Product Change Notification

Change Notification #: 113197 - 00
Change Title: Intel® Server System R2308BB4GC
PCN 113197-00, Product Design
Update the 750W Common Redundant Power
Supply FXX750PCRPS Firmware and
Change the Air Duct
Date of Publication: August 15, 2014

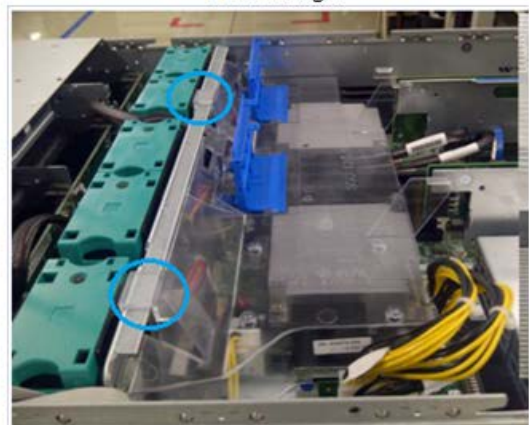
1. Update the 750W Common Redundant Power Supply FXX750PCRPS firmware revision to v100 to prevent a power race condition from occurring during an AC power loss event when the power supply is in cold redundancy mode.

Please refer to the Technical Advisory TA-1050-2 for more information.
